TAS5504A Errata

Figure 1. I²C Pullup Circuit (With No Series Resistor)

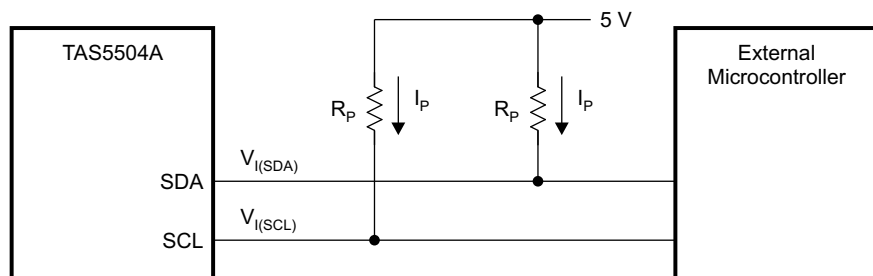
In systems using 5-V CMOS buffers for the I²C interface, special pullup resistors are required.

The I²C specification requires that V_{IH} is $0.7 \times V_{DD} = 3.5$ V when V_{DD} is 5 V. In some 5-V CMOS systems, the normal value for the I²C pullup resistor is 4.7 k Ω . This could cause the voltage not to rise above 3.47 V, which violates the specification. The root cause has been identified as a TAS5504A 5-V tolerant buffer issue.

It is recommended that the I²C pullup resistors, R_P , be 3.3 k Ω (see Figure 1). If a series resistor is in the circuit (see Figure 2), then the series resistors, R_S , should be less than or equal to 300 Ω .

M0012-01

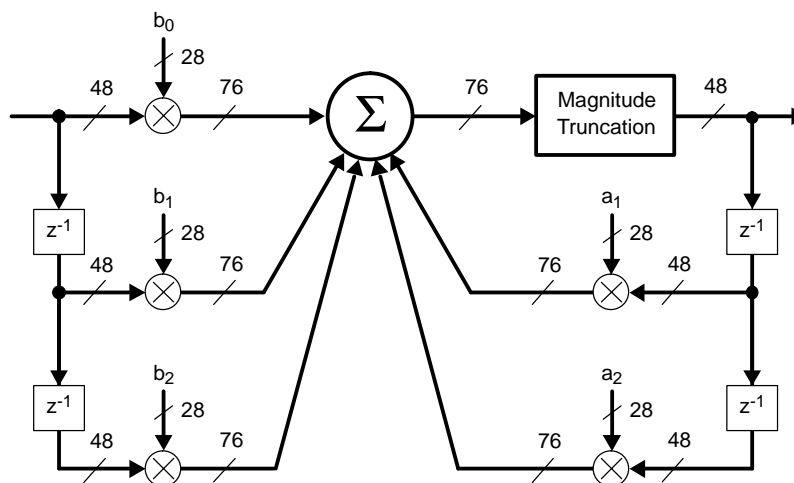
The TAS5504A exhibits a one-sample delay on channels 3 and 4 for sample rates of 32, 44.1, and 48 kHz. The delay occurs in the PWM section.

This time misalignment can impact applications where the TAS5504A is used to provide crossover filtering and bi-amplification, as in powered loudspeakers. The problem that occurs in these cases is that a one-sample time delay in either the high-pass or low-pass path causes an error in the overall crossover frequency response.

The time misalignment can be corrected by using a biquad to provide a one-sample delay for each of the nondelayed PWM channels for the 48-, 44.1-, and 32-kHz sample rates.

When the input and output mixers provide a 1:1 input-to-output connection, a four-channel loudspeaker configuration uses one of the seven biquads in channels 1 and 2 to provide a one-sample delay. This added delay realigns all four channels.

1. Set the b1 biquad coefficients to a gain of 1.
2. Set all of the other biquad coefficients (b0, b2, a1, and a2) to a gain of 0, as shown in the following diagram and table.
